NACIMIENTO WATER PROJECT
 ADDENDUM NO. 02
 for
 NWP FACILITIES
 CONTRACT NO. 300187.08-02
 SPECIFICATION No. 02

NWP NACIMIENTO WATER PROJECT

ADDENDUM

DATE:	August 1, 2007
PROJECT:	NWP Facilities
ADDENDUM NO.:	2
BID OPENING:	August 16, 2007

A1-E101 SHEET
87 OF 179

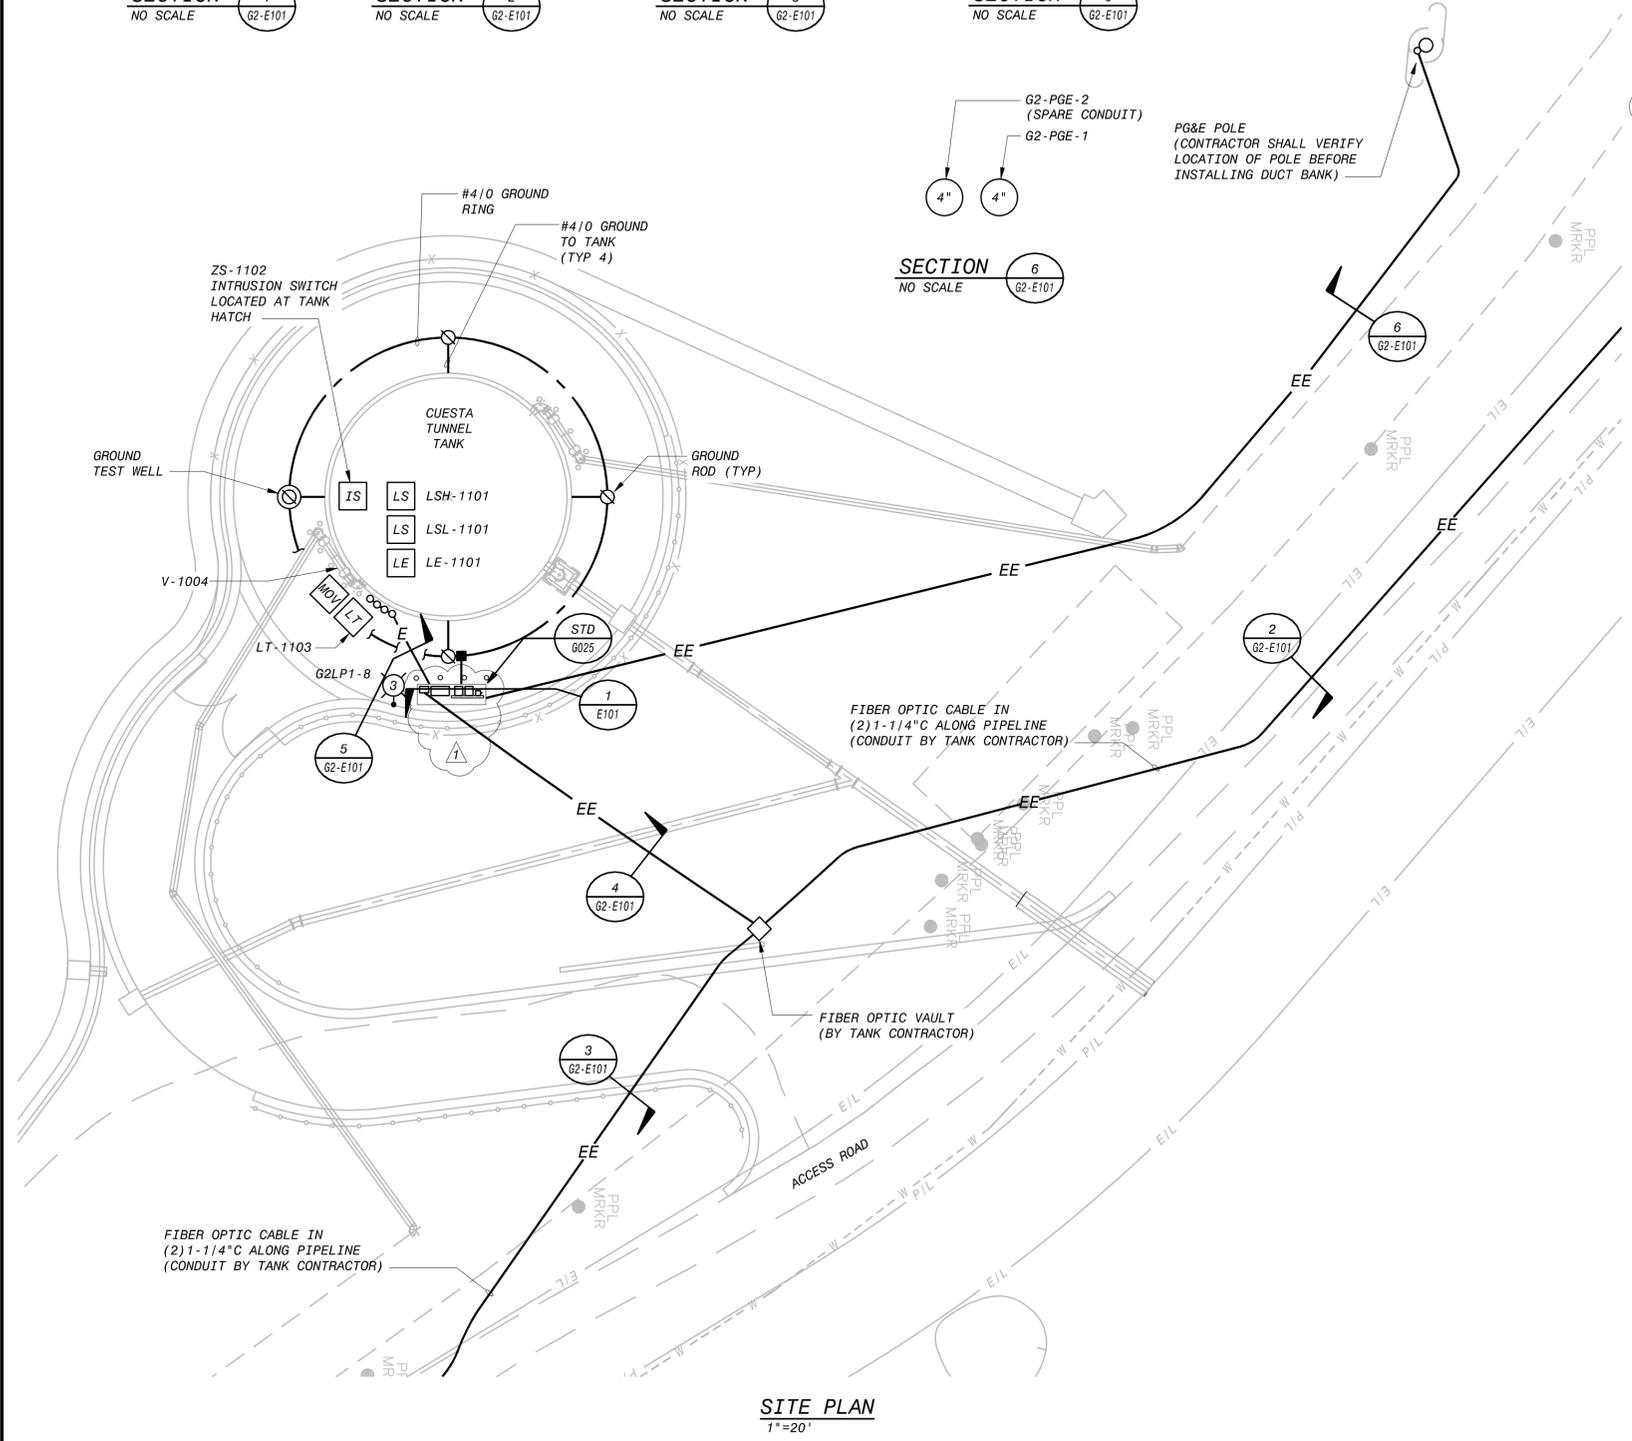
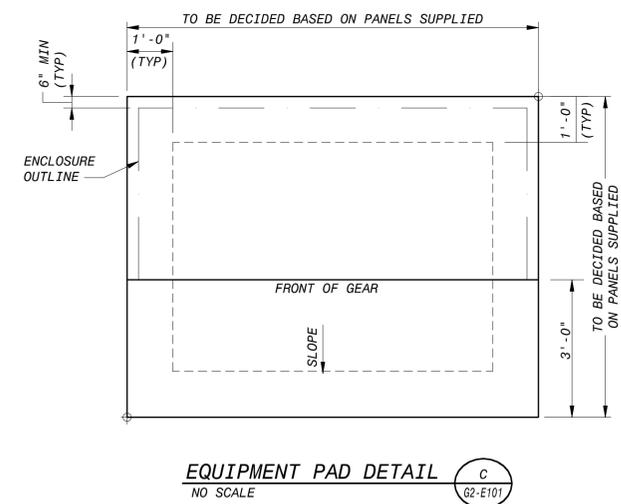
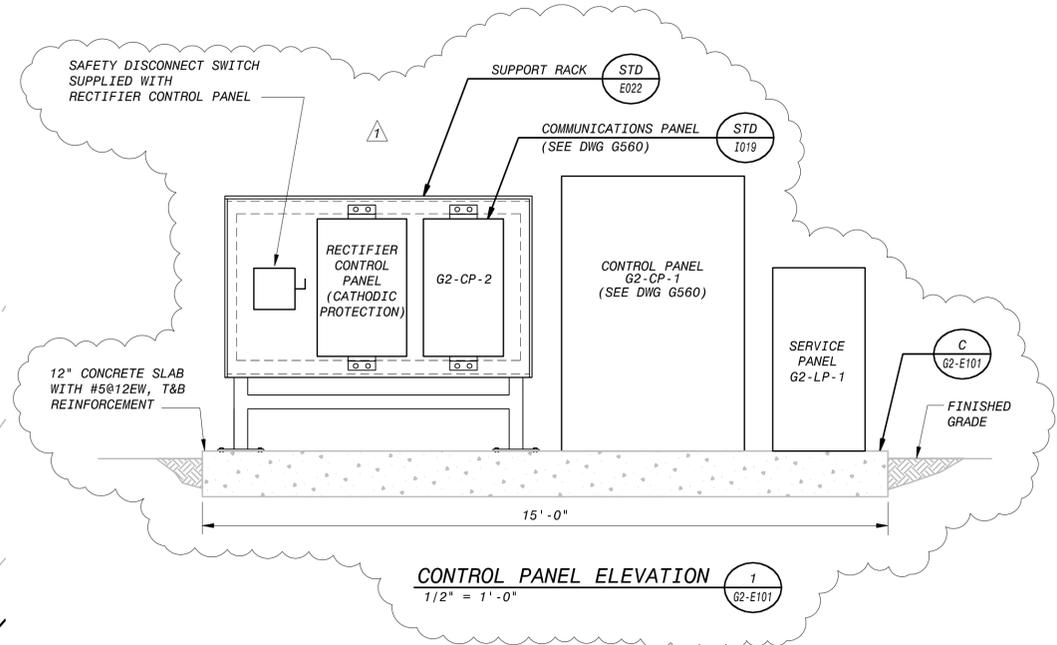
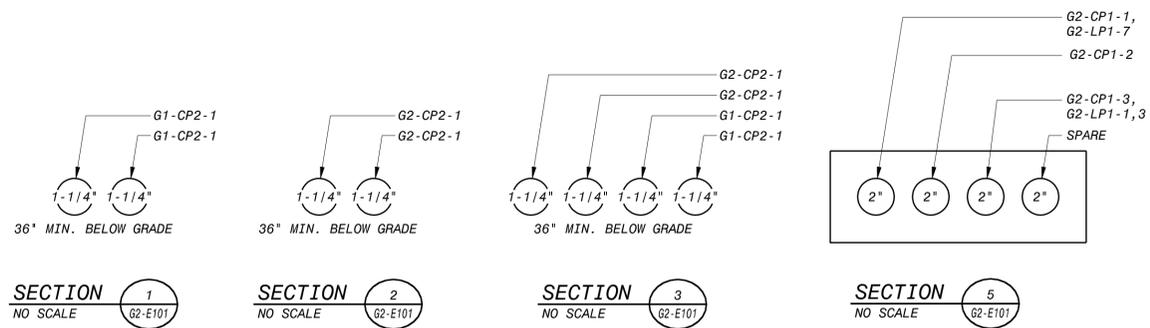
19. Drawing A1-E101, Sheet 87 of 179; revised drawing is attached.
20. Drawing A1-E601, Sheet 88 of 179; make the following revisions:
- On Communications Panel A1-CP-2 one-line diagram, change circuit A-CP2-3 to circuit A-CP2-1.

300187.08.02-SK25

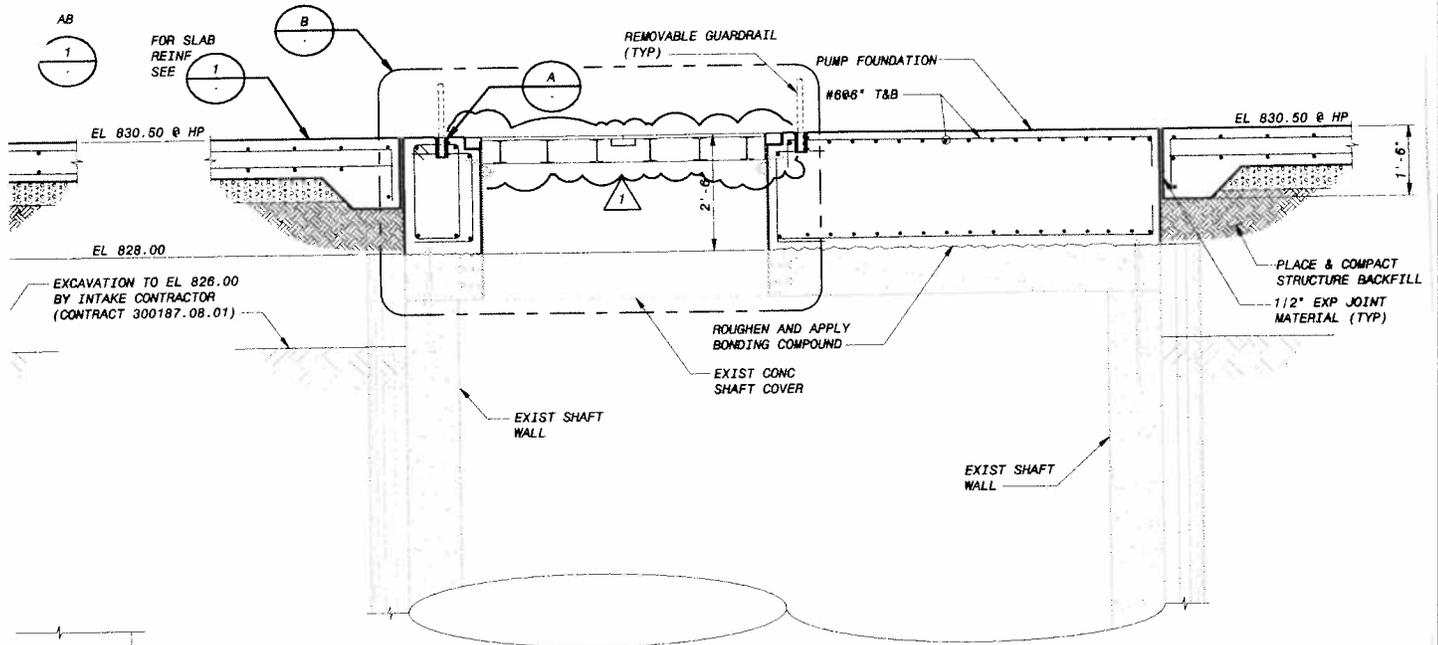
14. Drawing A-S101, Sheet 51 of 179; revise the shaft access hatch as shown on Sketch 300187.08.02-SK25.

A-S302

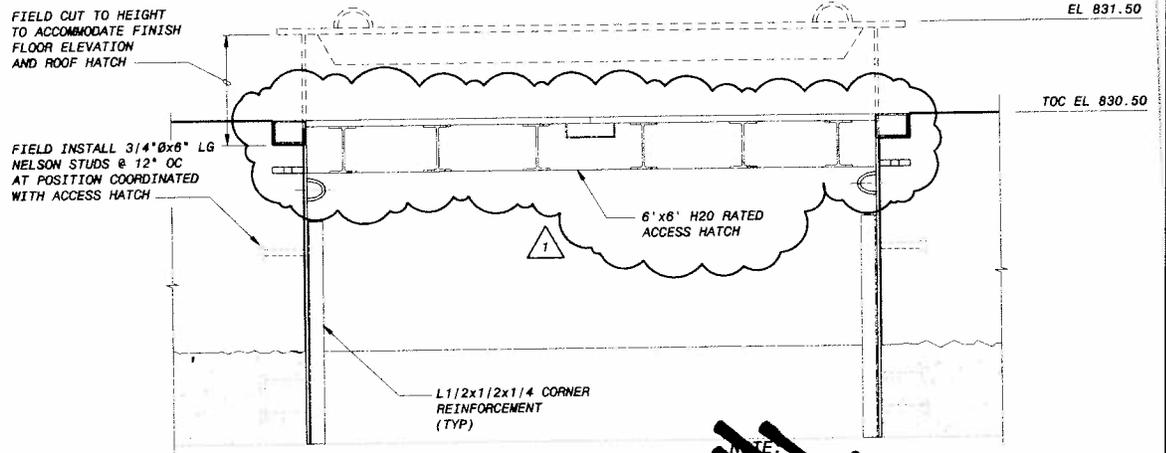
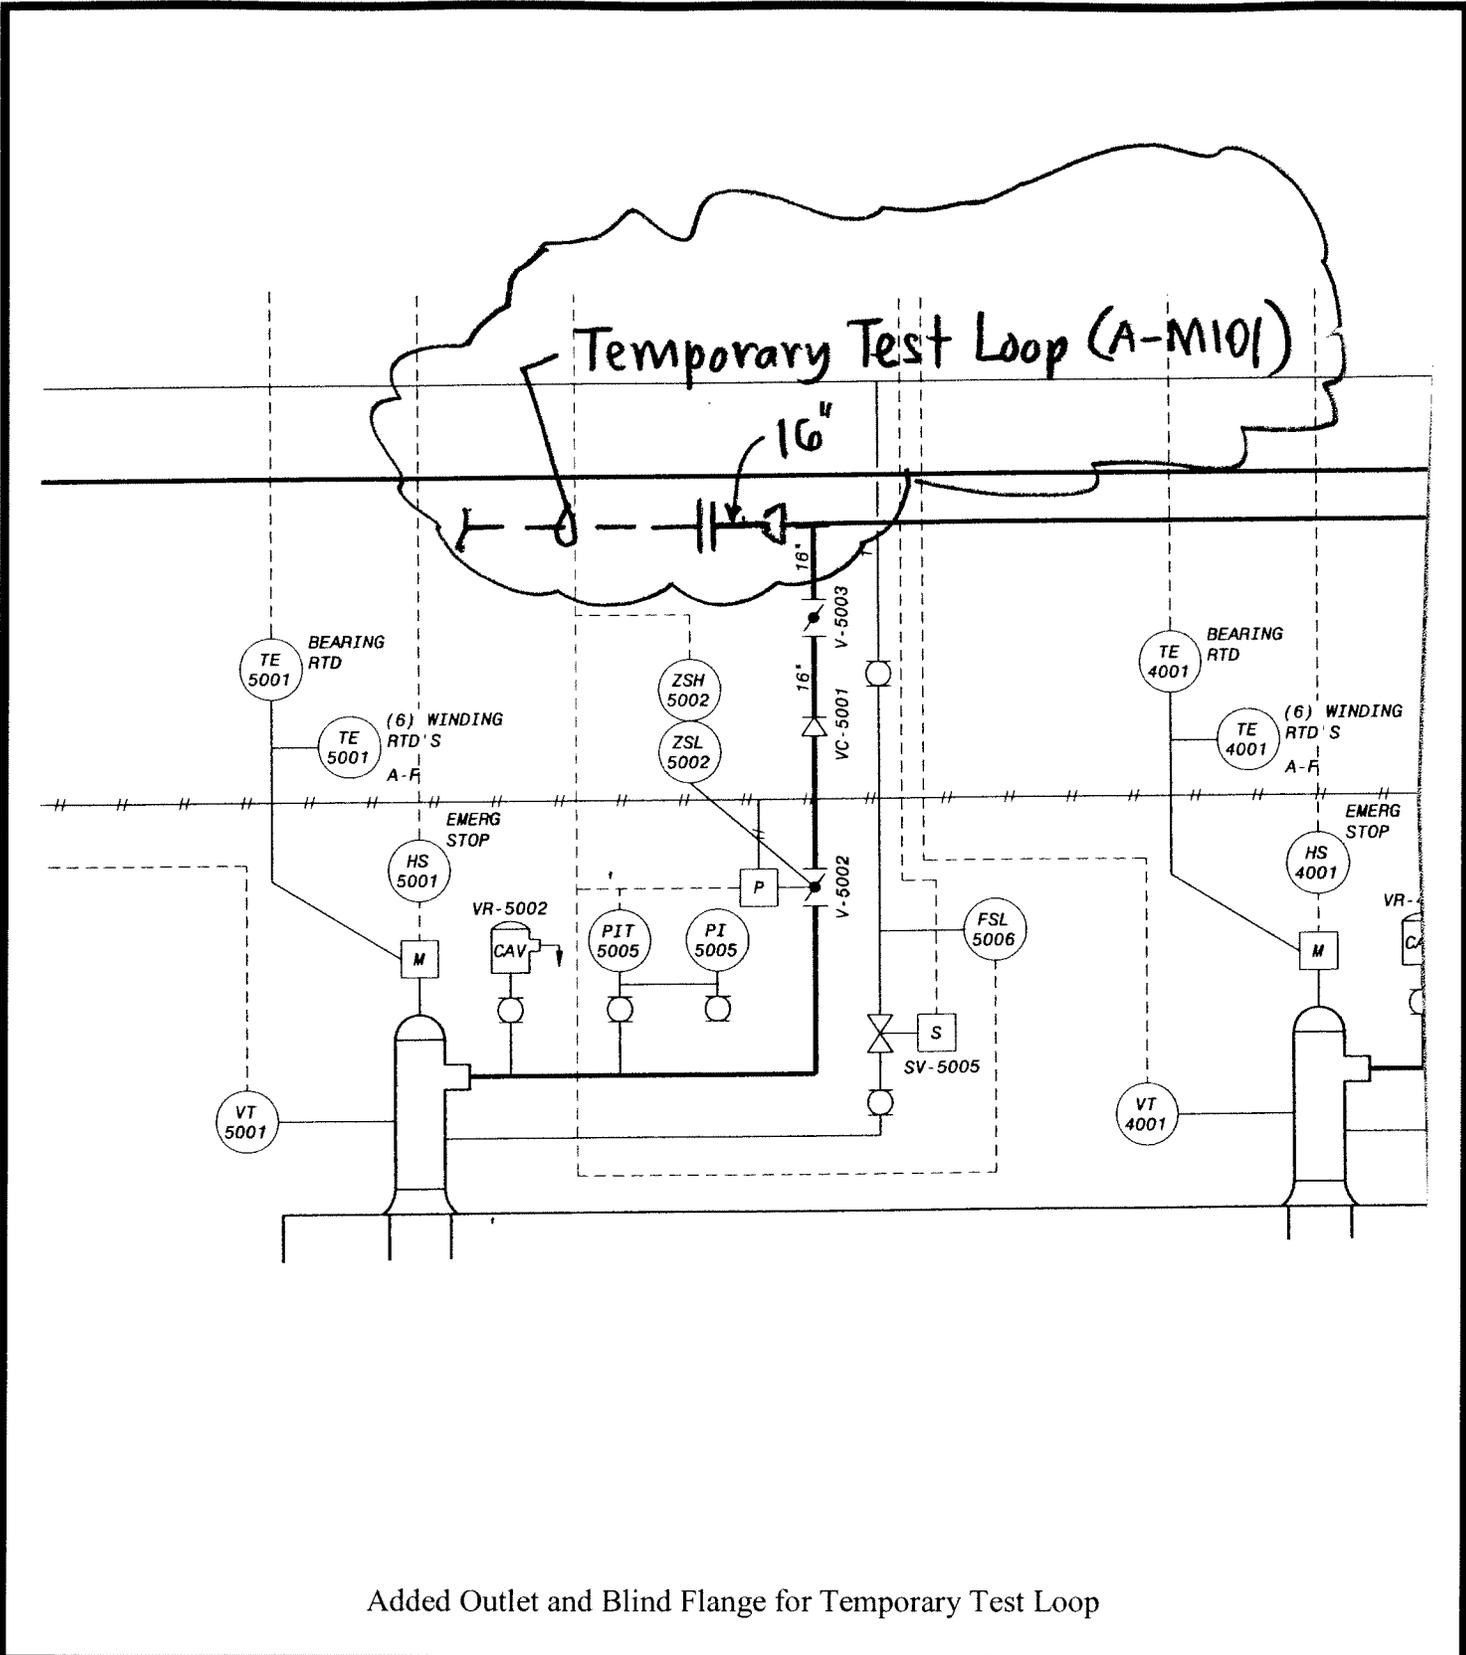
- Revise the shaft access hatch as shown on Sketch 300187.08.02-SK26 and delete the entire note making reference to B / A-C503.
- In Detail D, delete the note text making reference to B / A-C503 and replace with “FOR INFORMATION NOT SHOWN, REFER TO DISTRICT CONTRACT 300187.08.01, DRAWING A-C503”.
- In Section 2, revise the opening size from 1’-8” to 18”.
